Susan Flinn
Case 17-18: Basement/Cellar Measurement Rule
Submitted on January 18, 2018

Why Exclude Areaway as AFG?

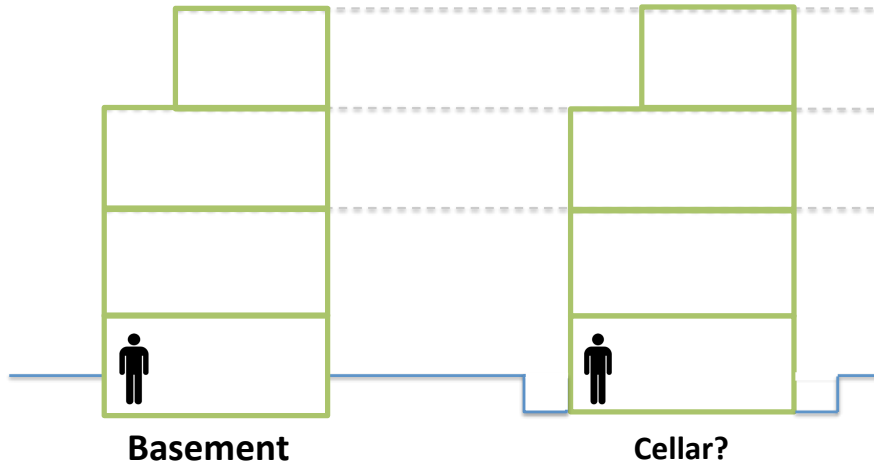
- Second, I oppose OP's proposal to exclude areaways from being defined as the "adjacent finished grade." Creation and use of an areaway is precisely the mechanism by which these spaces become "habitable" – by converting a non-habitable "cellar" into a habitable "basement." The areaway creates a new, lower grade and allows more light and air into the living space. It both creates "basement" grade-to-floor distance and makes the space livable. The areaway is, therefore, an intrinsic part of what makes the space livable, and it should be counted as such.

This illustration shows how an areaway turns a cellar into a basement. On the left is a basement, strictly from the 5' measurement distance. On the right is a cellar, if you don't measure from the

areaway, strictly based on the measurement distance. But, there's no logical reason *not* to consider the areaway as the adjacent finished grade; it IS the adjacent finished grade.

Example of an Areaway Scenario

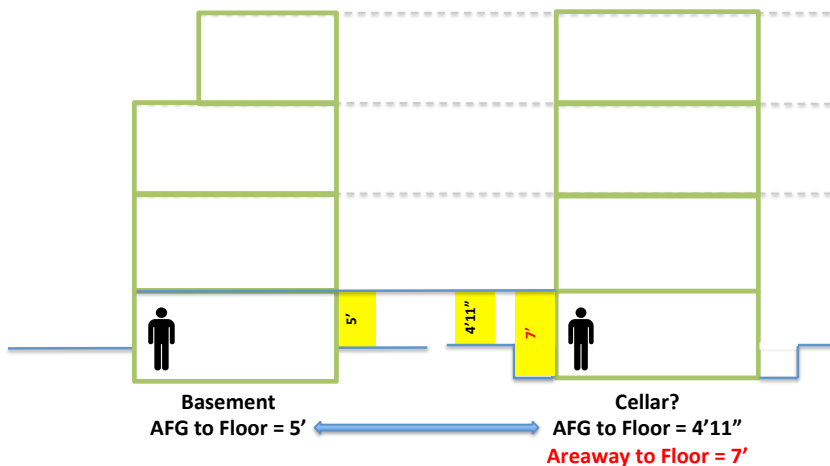
The following illustration shows how a 1" difference results in an illogical "cellar" definition when the areaway is excluded. On the right is a 5' measurement grade "basement." On the left is a so-called "cellar" with a 4'11" grade measurement, when the areaway is excluded. With the areaway included, the space has a new, 7' grade measurement. It makes no sense to call the living space on the right a "cellar."

Areaways should be used as the “adjacent finished grade.” Excluding areaways just invites the type of manipulation of the measurement rules that currently results in overbuilding. And, the City’s building codes, in the **ICC**, designate the grade measurement point at the façade’s base *and include areaways*.
